AENC-NG-CNS-REP-0292

Norwich to Tilbury

Document: 8.9.1 Applicant's Responses to First Written Questions

Planning Inspectorate Reference: EN020027

Drawing Number:
10059280-ARC-EGN-ZZ-DR-ZZ-00908
Revision:
A

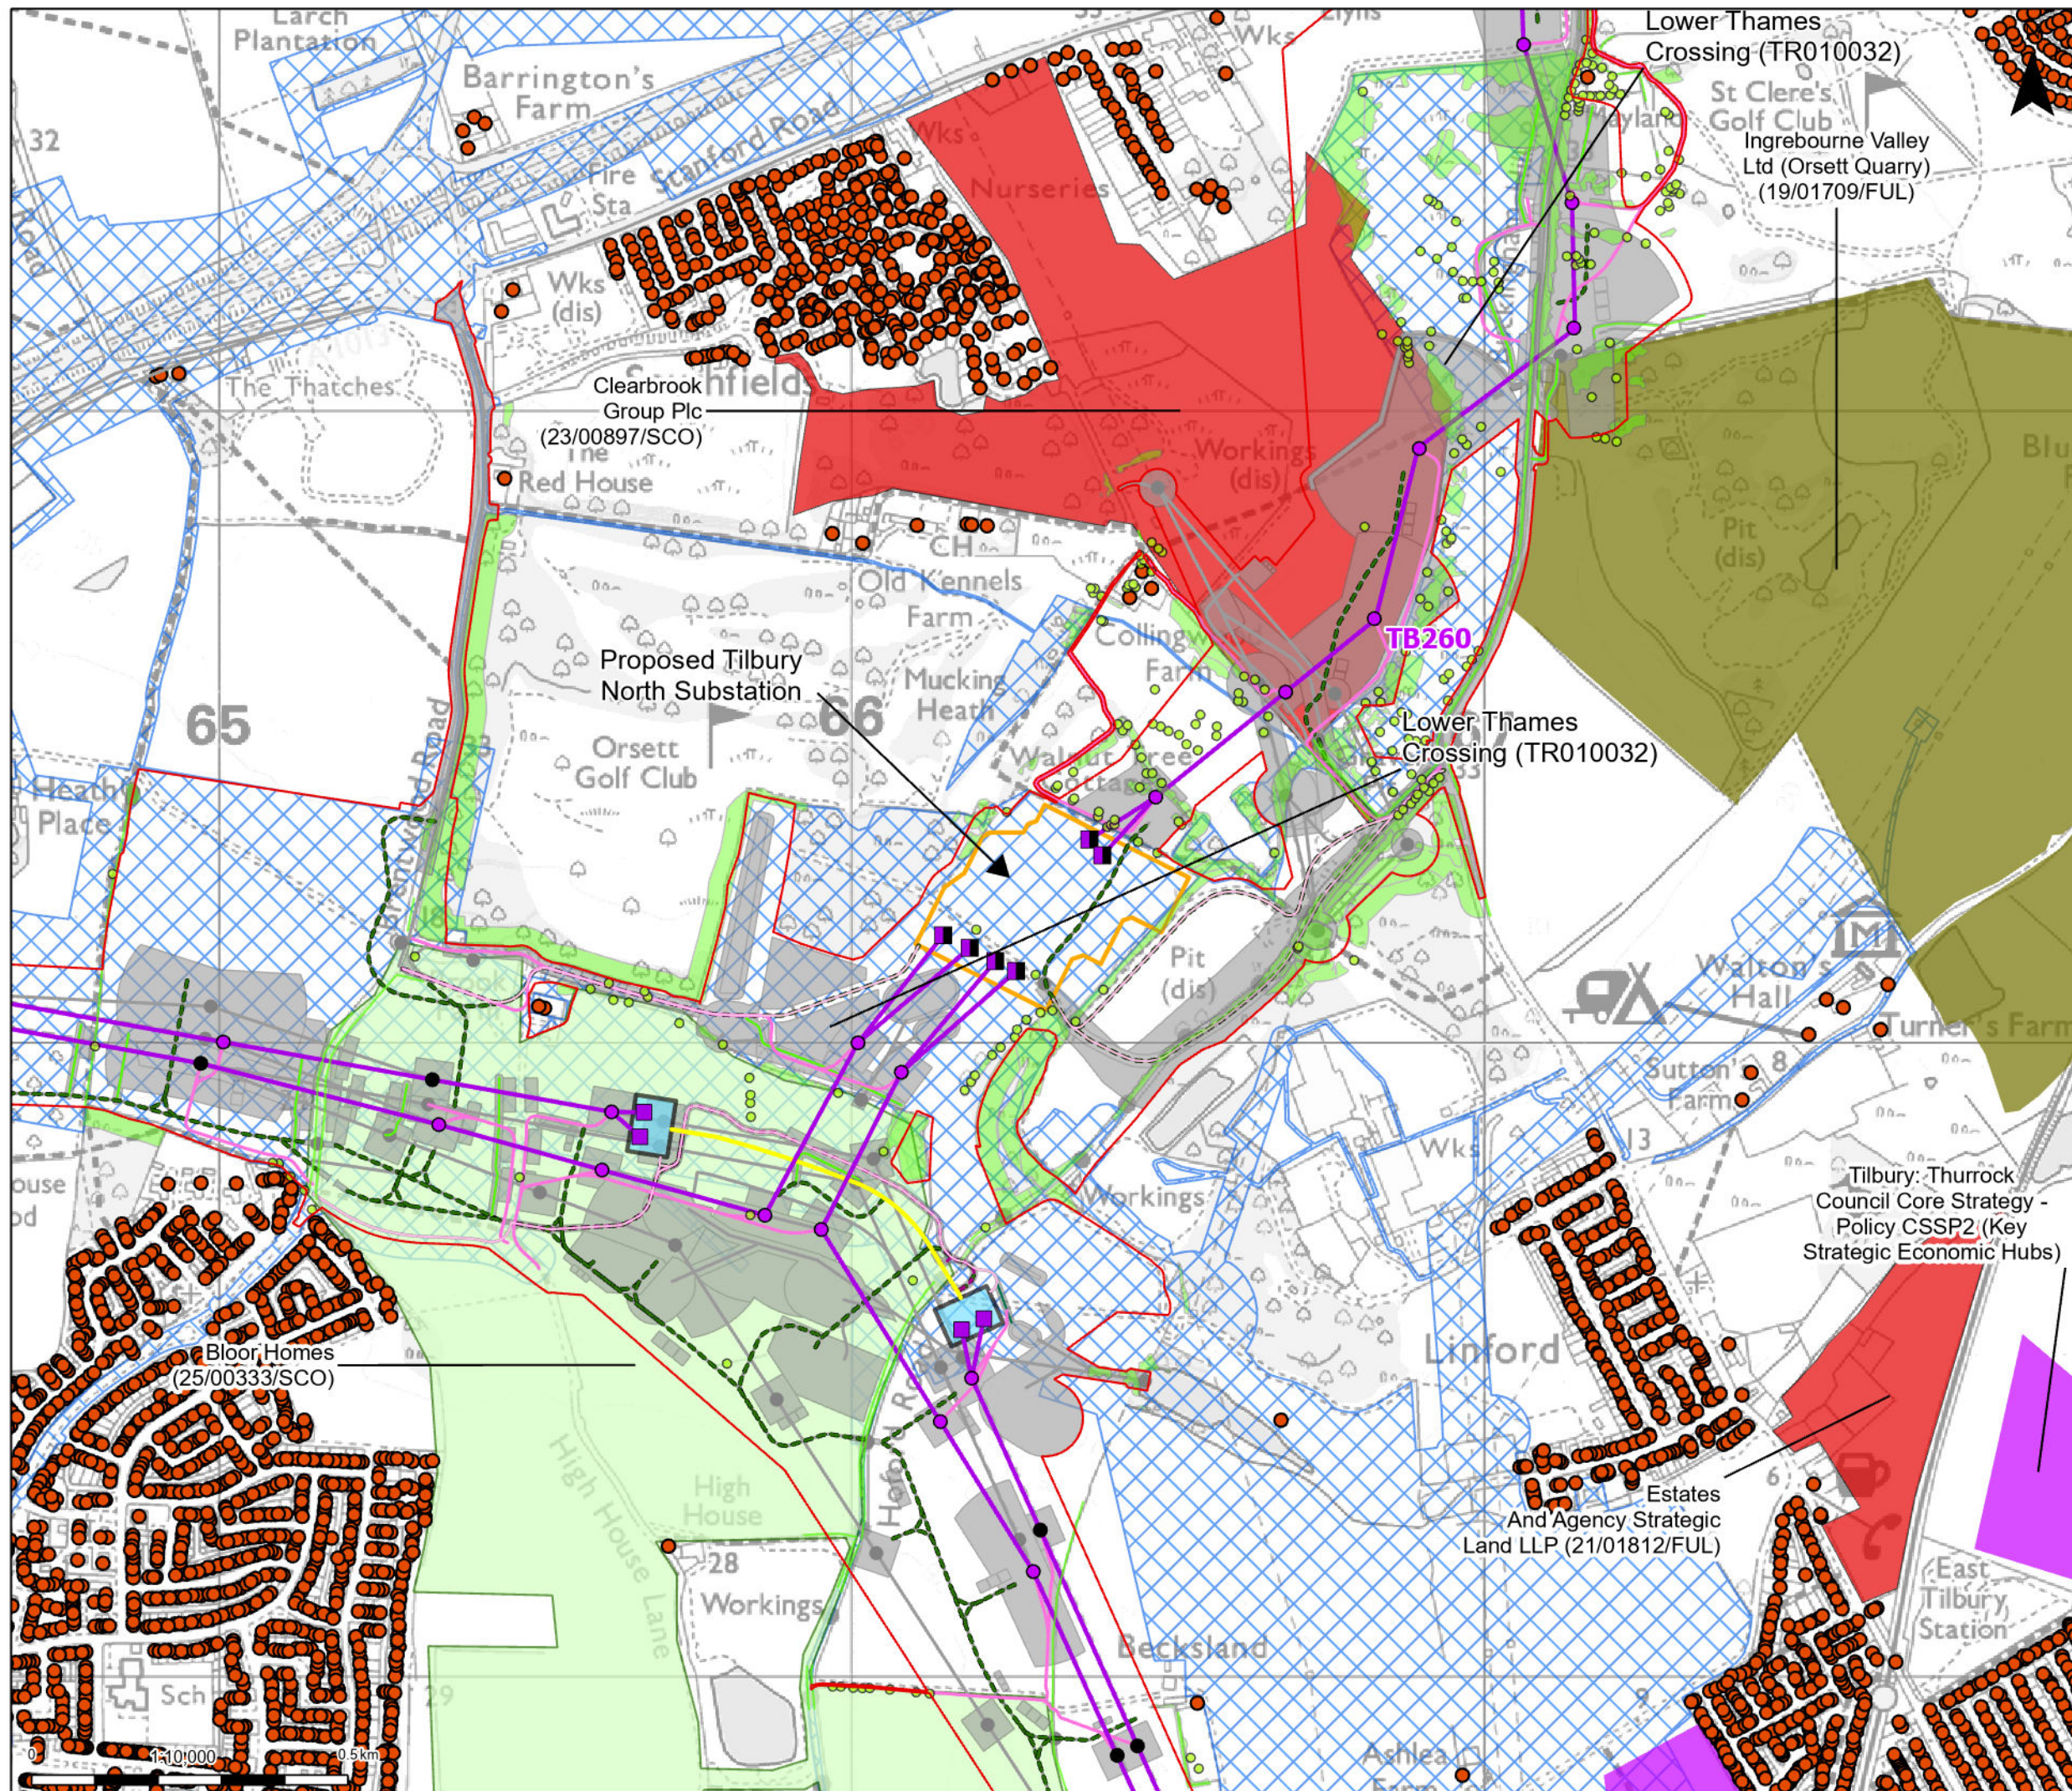
GEN 1.15	Norwich Main and Bramford substations and Tilbury North site – other developments Similar to the previous question, the ExA seeks separate labelled plans to an appropriate scale for the areas around the existing Norwich Main and Bramford substations and the proposed Tilbury North site which detail the surrounding existing and proposed developments, existing and proposed landscape features and access roads. Standalone plans should be provided at deadline 3 and incorporated in the	The Applicant has provided the requested plans in Appendix B to this document. The plans produced in response to this question have been labelled '<i>GEN 1.15 - Norwich Main and Bramford substations and Tilbury North site</i>', with separate sheets for each of the three locations. In addition, a separate plan has been provided for the area around the Norwich Main Substation that shows landscaping detail – please also see further explanation below. These plans will be incorporated into the next version of 8.4.3 Report on Interrelationship with Other Infrastructure Projects [REP1-134], due to be submitted at Deadline 4 of the examination. In producing these plans, the Applicant has used the following approach: - Scale: each plan has been produced at 1:10,000 scale - Project: the Tilbury North plan references the Project design at application, so reflecting the design prior to the Applicant's decision to proceed with scenario B. As previously notified to the ExA, Project design information is being updated later in examination, as confirmed in Additional Submission - Letter to the Examining Authority dated 9 February 2026 [AS-084] and 8.6.1 Deadline 1 Cover Letter [REP1-141]

Reference	Question	Applicant's Response
	next version of the interrelationship report at deadline 4.	- Surrounding existing and proposed developments: developments included in 6.17.F2 Environmental Statement Figure 17.2 - Short List of 'Other Developments' Considered within the Cumulative Impacts Assessment [APP-286] have been included and labelled with a reference to the development / developer name (consistent with any name used in 8.4.3 Report on Interrelationship with Other Infrastructure Projects [REP1-134]) and the planning application / Nationally Significant Infrastructure Project reference - Existing and proposed landscape features: - Existing landscape features: existing trees and hedgerows have been included. These features along with the impact on them are detailed on 6.13.A6 Environmental Statement Appendix 13.6 - Arboricultural Impact Assessment (AIA) Figure A13.6.1 - Arboricultural Impact Assessment [REP1-065] at 1:2,500 scale. - Proposed landscape features: features proposed at Norwich Main substation have been included on the additional version of the plan for that location. Plans for Norwich Main with and without proposed landscaping have been included due to the amount of information shown on the plans, to assist the Examining Authority's identification of the landscaping aspects. No landscaping is proposed for Bramford Substation due to space constraints. Proposed landscaping relating to Tilbury North earlier shown on application documents including 7.4 Outline Landscape and Ecological Management Plan Appendix D - Outline Landscape Proposals [APP-325] has not been included on the plan for that location, as updated detail is due to be produced and provided to the examination subsequent to the Applicant's notification to proceed with scenario B - Access roads: Project permanent and temporary access roads have been differentiated from other Project design data and labelled - Existing farmsteads and dwellings which bound the sites: The plans identify locations of these buildings rather than extents of entire landholdings, which may also include land

Supplement 4 - GEN

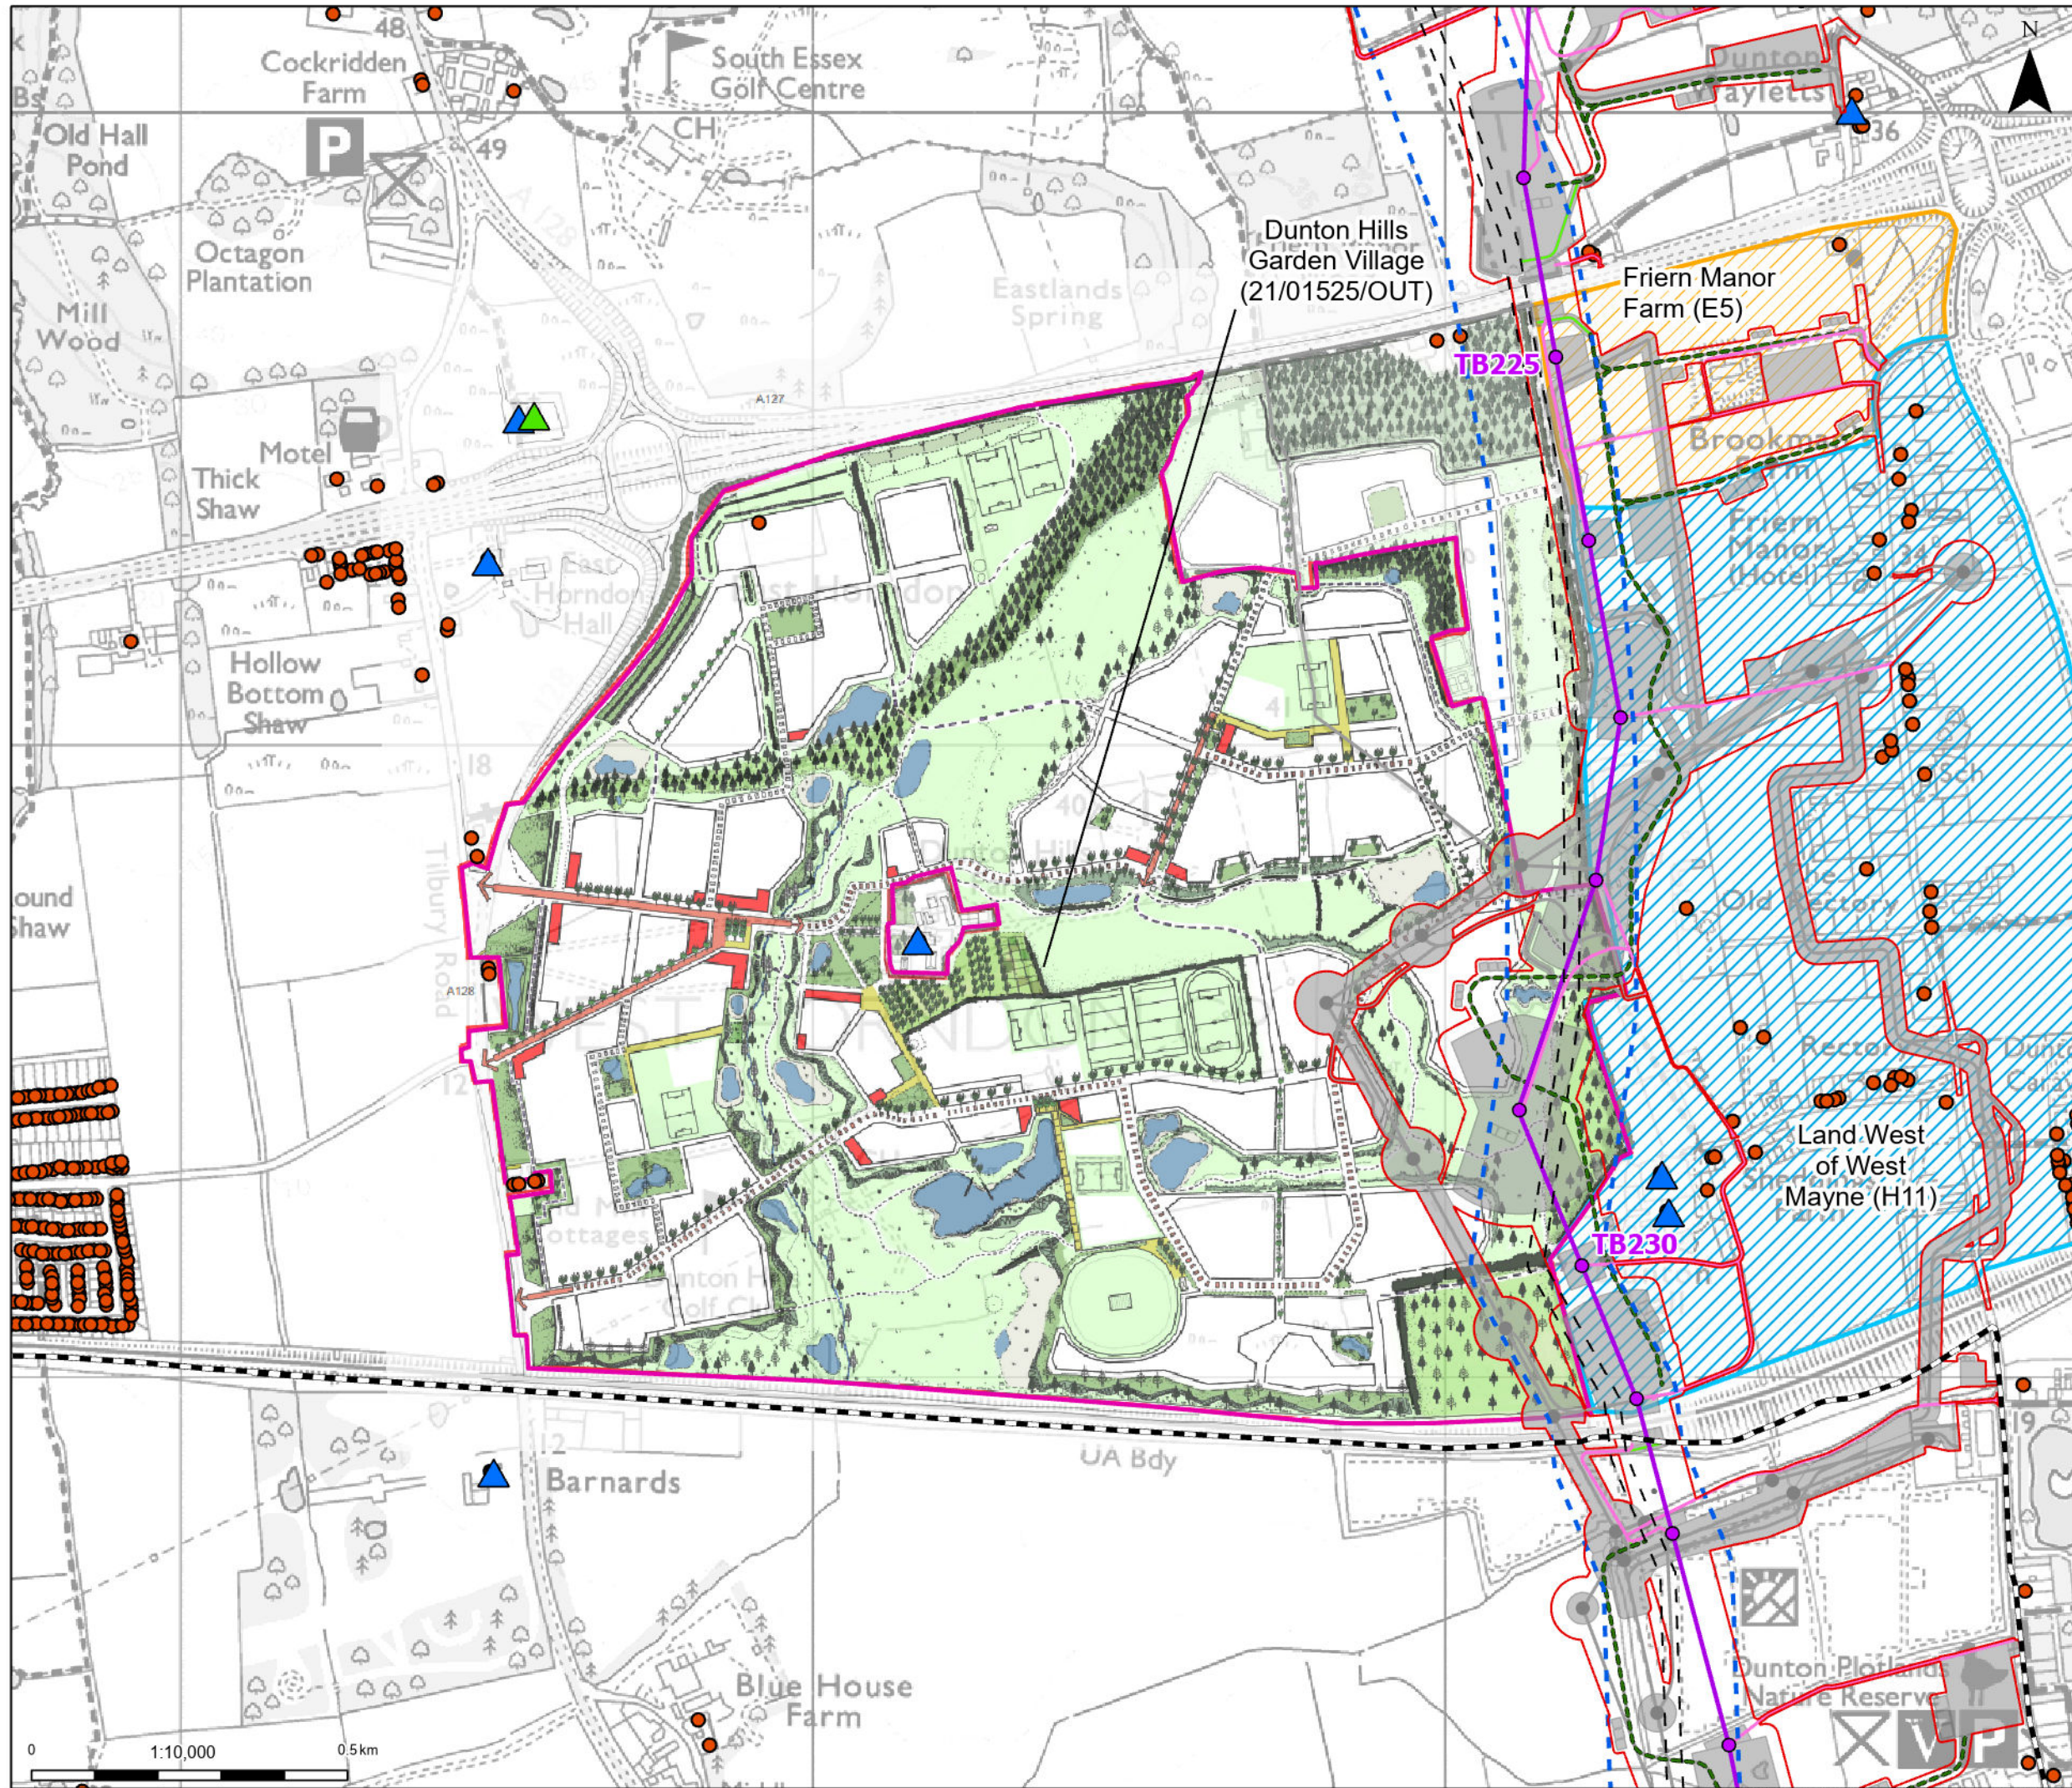
GEN 1.23	Dunton Hills Garden Village 1 A number of IPs have made submissions in respect of the allocated site Dunton Hills Garden Village (DHGV), including Essex CC [RR-1083] and [REP1-161], Basildon BC [RR-0335] and Brentwood BC [RR-0391] and [REP1-150]. The site is included in the cumulative assessment [REFs] and the interrelationship report [REP1-134],	The Applicant has provided the requested plan in Appendix C to this document. The plan produced in response to this question has been labelled '<i>GEN 1.23 – Dunton Hills Garden Village</i>'. Noting the issues raised by Interested Parties, the Applicant confirms the Project has considered Dunton Hills Garden Village during routeing and refinement of the alignment, resulting in the Applicant's decision to route the Project within an existing gas pipeline safety corridor. By doing so, and subject to final micro-siting, the total quantum of housing will not be affected. The Applicant also draws attention to the positions set out in 8.3.12 Draft Statement of Common Ground - LIH Dunton Hills Limited [REP1-082]. LIH Dunton Hills Limited has recently acquired the development interest for the land comprising Dunton Hills Garden Village.

Reference	Question	Applicant's Response
	and ES chapter 15 [APP-265] details this and other allocations on pages 115 and 116. These include North Billericay, Queens Park (AS1 Allocation) (Section G); DHGV (Section G); and Land West of West Mayne (Section G). The applicant is asked to provide a clear plan of a suitable scale which overlays the proposed development with the allocations and the DHGV approved masterplan (or outline plan), as well as other constraints including the existing gas pipeline and the Build Protect Design corridor.	In producing this plan, the Applicant has used the following approach: • Scale: the plan has been produced at 1:10,000 scale • Allocations: – North Billericay, Queens Park (AS1 Allocation) (Section G): This proposed allocation was included within Basildon Borough Council's Regulation 18 Part 2 consultation. However, it has since been removed as a proposed allocation within the Regulation 18 Part 3 consultation, replaced with a smaller site identified as H31 (Land at Mountnessing Road), which does not interact with the Project's Order Limits. Due to the removal of the site that had interacted physically with the Project's Order Limits, and to avoid confusion about interrelationships, the Applicant has not shown the proposed allocation AS1 on the plan provided in response to this question. – Land West of West Mayne (Section G): There are two allocations east of Dunton Hills Garden Village that interact physically with the Project – Friern Manor Farm (E5) and Land West of West Mayne (H11). Both have been shown and labelled on the plan. • Dunton Hills Garden Village approved masterplan: As well as the boundary for planning application 21/01525/OUT, the plan provided in response to this question includes detail from the Dunton Hills Garden Village Illustrative Masterplan dated August 2022 (developer references: job number 31057, drawing number 400, revision H). Please note that the developer's masterplan shows housing as white blocks, and this has been replicated in the plan being the Applicant's response to this question. • The existing gas pipeline and the Build Protect Design corridor (80 m buffer around the pipeline) have been shown on the plan. • Other constraints: There are a number of Listed Buildings in the vicinity of the Project and the above allocations / proposed developments, which have been shown on the plan. • Access roads: Project permanent and temporary access roads have been differentiated from other Project design data and labelled.

Reference	Question	Applicant's Response
		Existing farmsteads and dwellings: The plan identifies locations of these buildings rather than extents of entire landholdings, which may also include land.
GEN 1.24	Dunton Hills Garden Village 2 The RRs and LIRs from Essex CC [RR-1083] and [REP1-161], Basildon BC [RR-0335] and Brentwood BC [RR-0391] and [REP1-150] make detailed comments regarding potential effects on the viability and delivery of the DHGV allocation which may be affected by the OHL infrastructure. Existing pylon infrastructure is in place on and around DHGV. Work no. 33 includes the replacement of part of an existing overhead distribution electric line. The works include removal of 1.9 kilometre (km) of existing pylons and OHLs (route PSC) and the installation of 1.6km of new underground distribution electric line, with a temporary diversion of the existing line. These works are shown on works plans section G (sheet 6 of 6) [APP-023] and section H (sheet 1 of 7) [APP-024]. However the submissions include limited consideration of the existing OHL which crosses the allocation, and the proposals by the applicant to remove and underground part of the existing electric lines.	It is noted that part a) of this question is addressed to the Applicant: The Applicant agrees with the description in the question which notes that the Project only requires the existing 132 kV PSC (UK Power Networks) overhead line to be placed underground due to the proposed 400 kV TB route overhead line needing to cross it. This is reflected by Work No. 33 on sheet 6 of 6 in 2.3 Works Plans - Section G [APP-023] and sheet 1 of 7 in 2.3 Works Plans - Section H [APP-024]. The second existing 132 kV PUB (UK Power Networks) overhead line that crosses the western part of the Dunton Hills Garden Village (DHGV) allocated site is unaffected by the Project and therefore the Applicant has made no proposals to underground it. The Applicant does, however, understand that a core premise of the DHGV proposal is to remove the two existing 132 kV (UK Power Networks) overhead lines that cross the site. The Applicant is not aware of the details regarding the more western PUB overhead line and has not been party to discussions between LIH Dunton Hills Limited and UK Power Networks on the matter. The image below provides an overlay of the temporary and proposed Project works on the Dunton Hills Garden Village proposals.
